# Atlas Minerals

Atlas Minerals is hereby requesting that Source Material License SUA-917, Docket No. 40-3453, be amended to incorporate the enclosed tailings pond design modifications and changes in operating controls. Modifications to the embankment system will begin immediately and be complete within 90 days. A qualified geotechnica! engineer will inspect the construction of the embankment modifications on a weekly basis.

# OF TAILINGS DISPOSAL SYSTEM AT ATLAS MINERALS MILLING OPERATIONS, MOAB, UTAH

FILL OF RIVER RUN GRAVEL/SAND PERFERNTED DRAIN PIPE-PLACED AT SEEP - NORTH EMBANKMET VOETH EMBANKMENT Figure 2

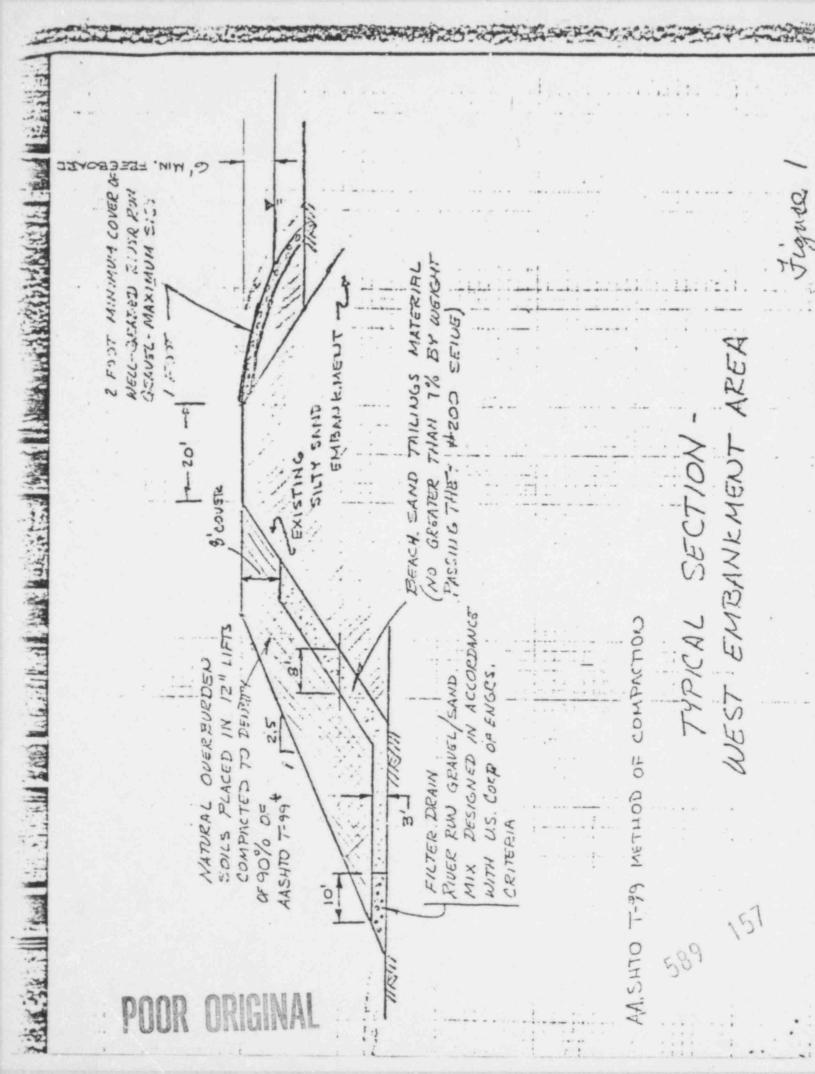
Construction of an overburden fill will be placed over the seepage area located at the north embankment too. The construction requirements and dimensions are shown on Figure 2 and include the following:

- 1. An overburden fill of well-graded river run gravel will be placed over the seep area a distance of at least 50 feet in all directions from the seep. The minimum fill thickness of 5 feet will be met over the above stated area. The maximum particle size of the material will be one foot.
- A perforated drain pipe will be placed as shown on Figure 2 and drained by pipe to a sump pumpback system located near the downstream toe of slope.
